Cree LED HB SMD LED Product Change Notification

CreeLED-PCN-5291

Cree LED Part Number
CLM2C-xxx-xxxxxxx

The drawing of CLM2C is revised as follows:

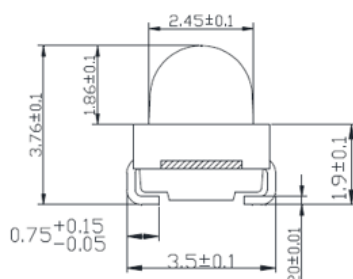
The specification of the above product series has changed. Correction of the product height dimensions are marked, but the actual product height is not changed. Please refer to the latest data sheets on www.cree-led.com.

Modify the drawing dimensions based on Production data.
